# Technical Notice

Mustang-V100-MX8-R11

**Implementation Type:** Running Change

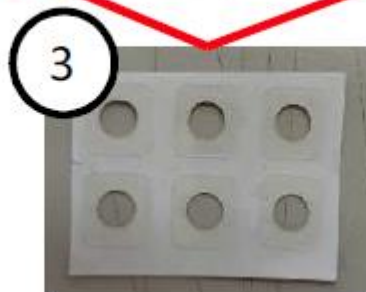
PCB surface scratched by bracket.

Add two MYLARs which stick on bracket to avoid PCB surface damage

The implementation start from “SN Q214I20842”
